# An Opportunity to Renew

This document has been put together to support a submission by R3 Residents

The document is intended to support submissions by the R3 residents and should be read in conjunction with the APP submission document and also the "Showground Station Precinct R3 Economic Viability - A Residents' Perspective" document.

## Connect Fishburn Crescent through to Showground Road

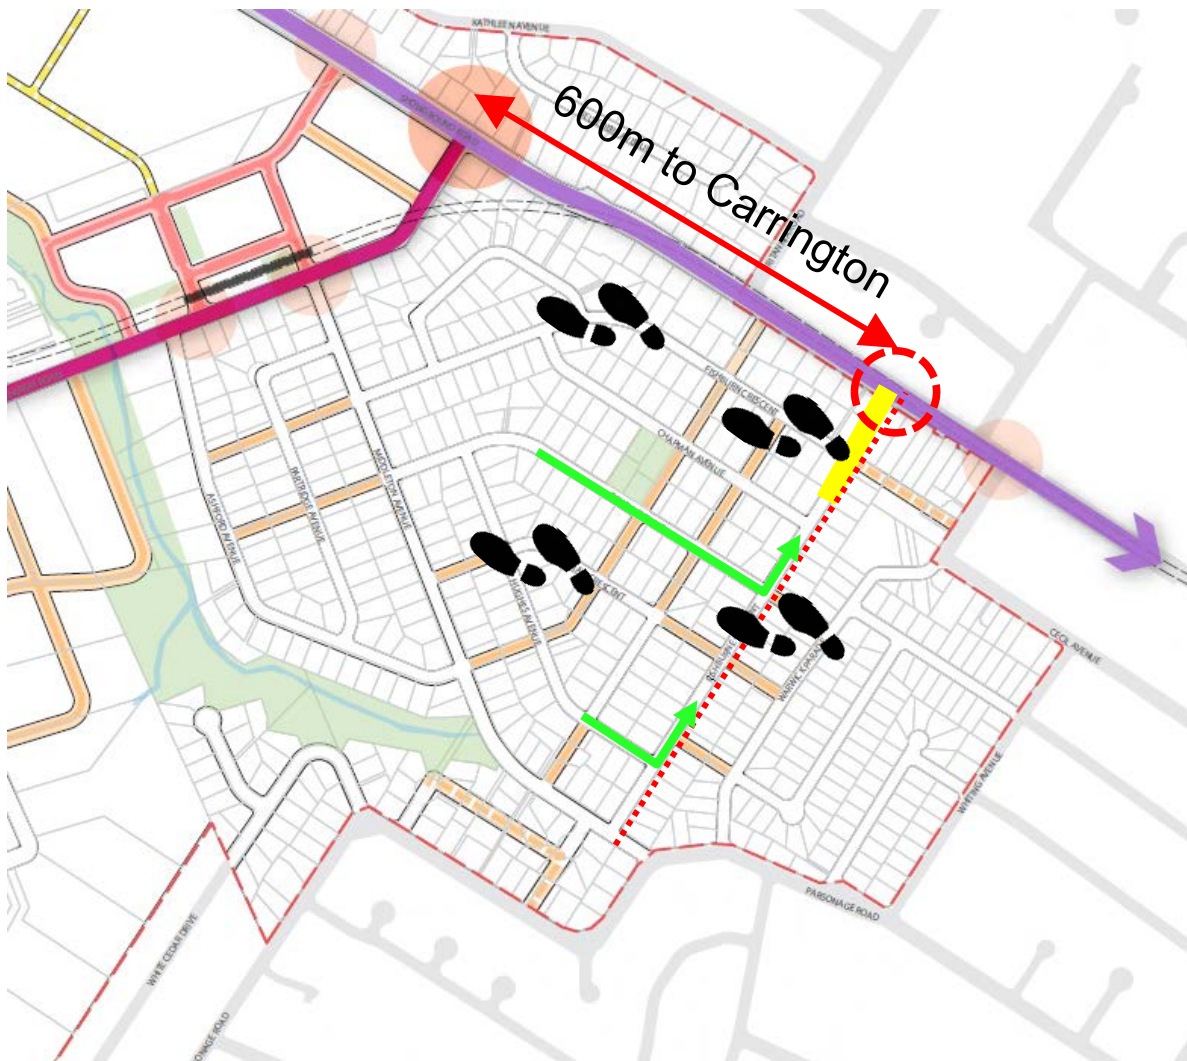
With extra dwellings in the precinct, it is imperative that access be provided to Showground Road in some way. The existing proposal is to extend Ashford and run a road right through to 52 and 54 Fishburn Crescent, down onto Showground Road.

We do not believe it is the preferred option for a number of reasons:

- It cuts the precinct in two, which means that opportunities like the large 2+ha park simply could not be built.
- It limits the opportunities to master plan and to provide flexible building areas.

Similarly shifting the Ashford extension to the west to align with Britannia Road might appear attractive but it would suffer from the problems just mentioned, and worse would introduce traffic into the precinct from the north.

It would be far better to have an appropriately designed intersection, connecting Fishburn Crescent to Showground Road ...

Fishburn Crescent would become a very **well defined precinct boundary, with traffic funnelled to the precinct edges**, keeping it out of areas best kept for people.

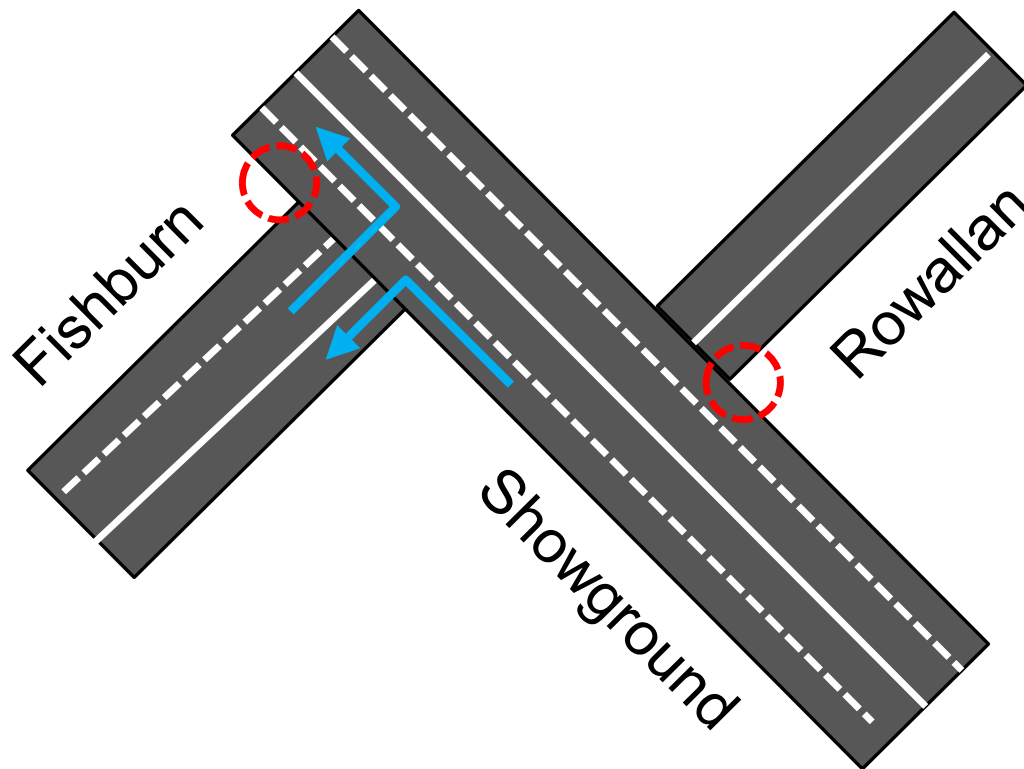
In addition the intersections of Showground Road with Rowallan and Fishburn could work well as follows:

The intersection with Rowallan is about 120 metres from the intersection with the proposed extension of Fishburn Crescent. Travelling at 60 kph, a vehicle will traverse that distance in just over seven seconds.

120 metres would also mean that almost the entire peak hour flow of cars from Rowallan could 'park up' in the space on Showground Road between Rowallan and Fishburn. They would wait for the right turn lights from Rowallan, turn onto Showground Road and then wait for the Fishburn lights to turn to green (while cars exiting Fishburn were getting onto Showground). If you are worried about having space between Rowallan and Fishburn, you could phase the Fishburn stop signal just 5-10 seconds after the Rowallan top signal – it would free up more than enough space. The volume of cars from Rowallan is miniscule in any event and the intersection should be designed around the Fishburn volumes which are likely to be greater at peak times.

We suggest that the following also ought to be considered in any design:

- Having dual lanes exiting the precinct, as you want minimal interruption to the Showground Road flow. You want cars from the precinct to get onto Showground in numbers and quickly once the lights go green.
- Allow for a small amount of widening of Fishburn up the hill to facilitate any queuing that might be needed for the lights. Having 80-90m of double lanes however should reduce this requirement somewhat.
